### CITY OF SEATTLE ANALYSIS AND RECOMMENDATION OF THE DIRECTOR OF THE DEPARTMENT OF PLANNING AND DEVELOPMENT

**Application Number:** 3012601

**Address of Proposal:** 3400 Stone Way N

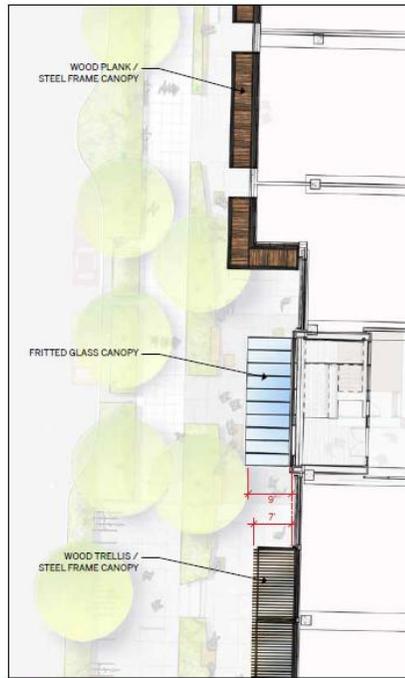
- 2) The uppermost (5<sup>th</sup>) level of the building on the northwest portion of the building was stepped back to recede from views at the pedestrian level at the intersection of Stone and 34<sup>th</sup>. The ground level open space at the north side of the project (along 35<sup>th</sup>) was not reduced. The Board was impressed with the responsiveness to the guidance provided at the previous meeting and agreed that the revised design addressed the height, bulk and scale issues.

- 3) The projecting trellis feature shown at the top of the southwest corner was significantly reduced and the color lightened to reinforce the fading of the building height and mass. The Board was satisfied that these changes reduced the presence of the building bulk at this corner.

- 4) The cornice line at the fourth level was strengthened to emphasize the building at this lower floor with a contemporary parapet design that emphasizes the change in plane between the fourth and fifth levels. The cornice designs were adjusted to vary between the independent masses and avoid a singular continuous line. The Board was satisfied with the revisions. (See image above)
- 5) The material language of the fourth level of the northern portion of the building along the Stone Way elevation was carried to the south and down the two bays which meet the retail level. The use of wood at the retail ground level retail remained limited to the corner. The Board was satisfied with the revisions and agreed that the changes helped differentiate the building forms and break down the scale of the building.(See image above)

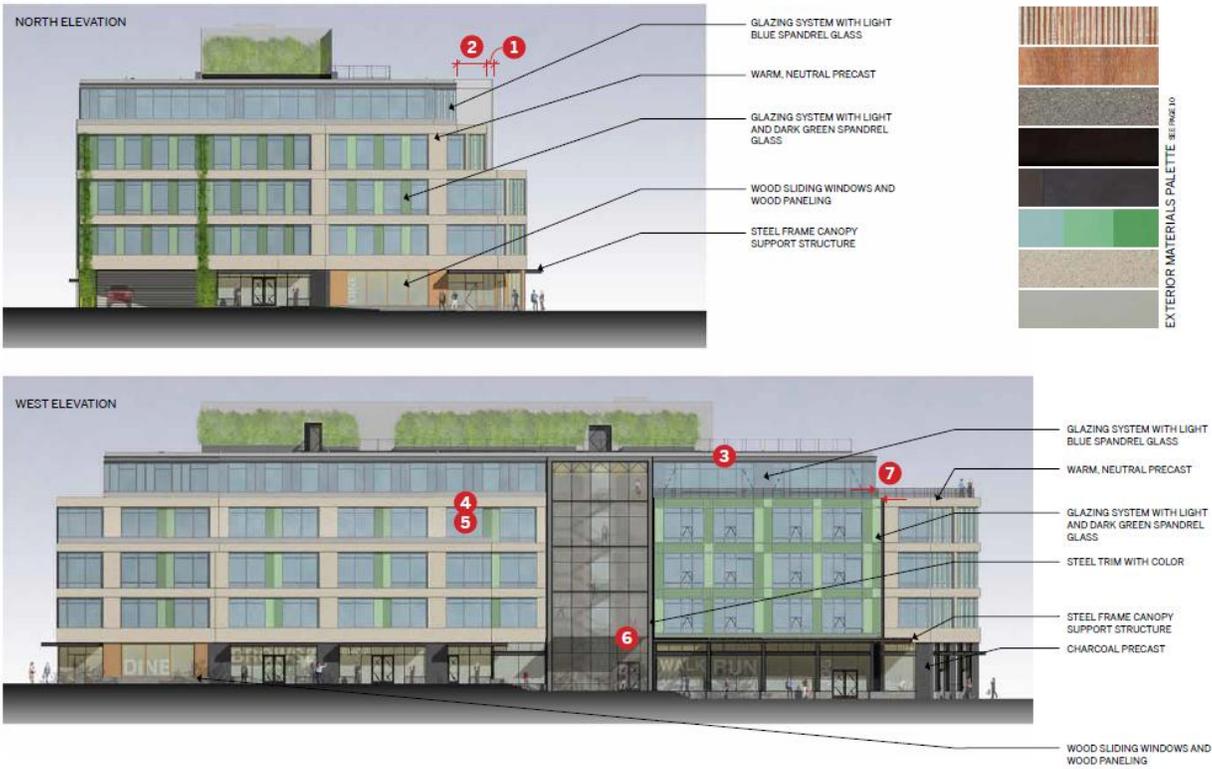
- 7) A transition between materials was amended to accompany a change in plane:

- a. The projecting entry bay and north and south building modules all include a change in plane that is coupled with a change in material.

b. The top floor at the southwest corner was revised to use the solid pre-cast for the building
